## PEDESTRIAN PLAN RECOMMENDATION

RE: Barton Springs Pool Improvements  
Planning Commission Consolidated Site Plan  
Engineer's Summary Letter - Revised  
PBS&J Project No. 440128.00

Subject: Construction of Pizzitola Boat dock at 3113 Brass Buttons Trail  
File No. SP-99-2082DS.

Subject: Construction of Jeffries Boat dock at 3106 Rivercrest Drive  
File No. SP-99-0198DS.

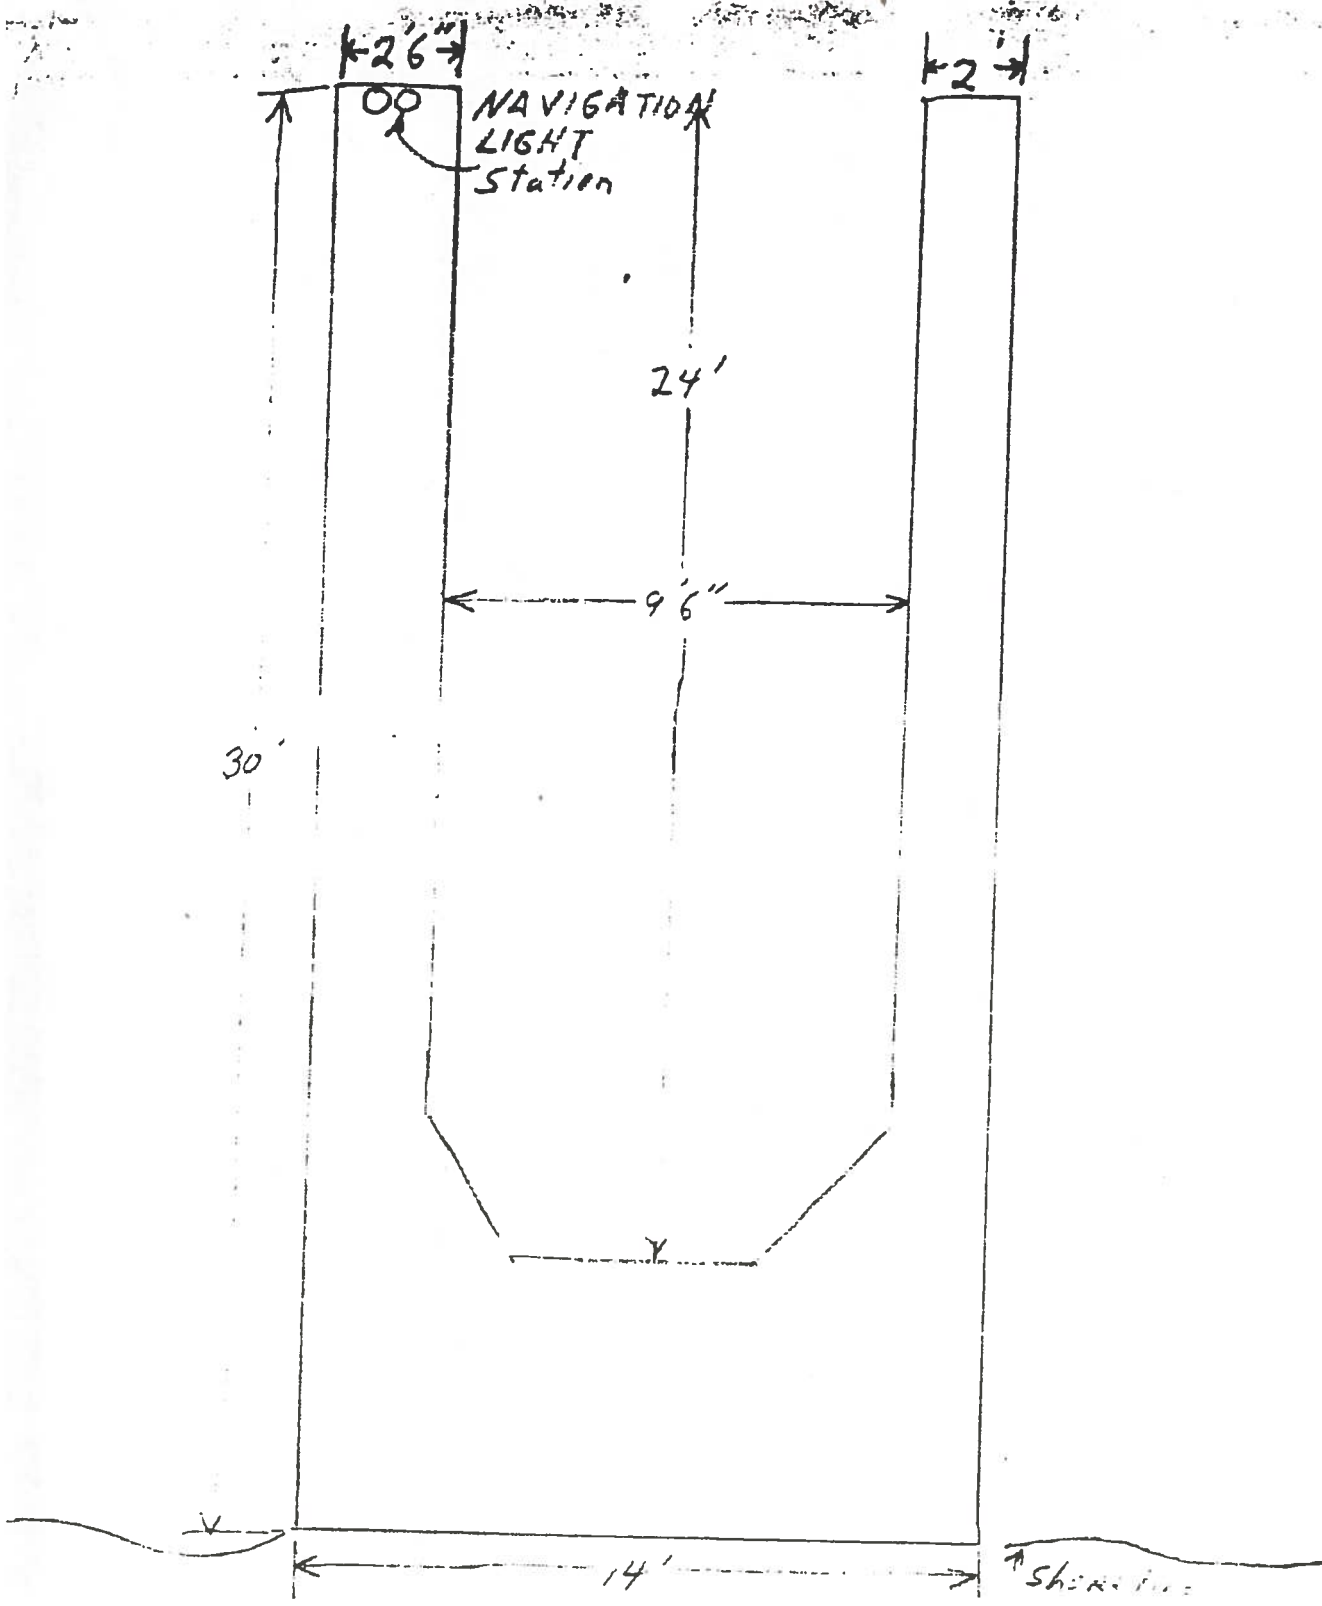
The Parks and Recreation Department (PARD) staff has reviewed plans for the proposed project and finds they meet the requirements of Article XIII, Section 25-2-1176, (Regulations for the Construction of Boat Docks) of the Land Development Code.

I recommend approval of the above request as detailed in the attached site plan.

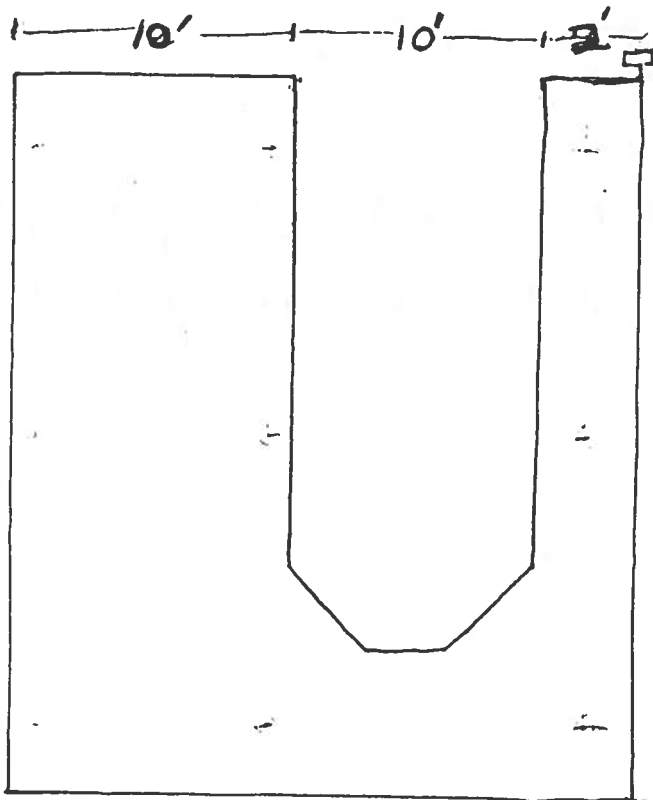
The Parks and Recreation Department (PARD) staff has reviewed plans for the proposed project and finds they meet all the requirements of Article XIII, Section 25-2-1176, (Regulations for the Construction of Boat Docks) of the Land Development Code.

I recommend approval of the above request as detailed in the attached site plan.
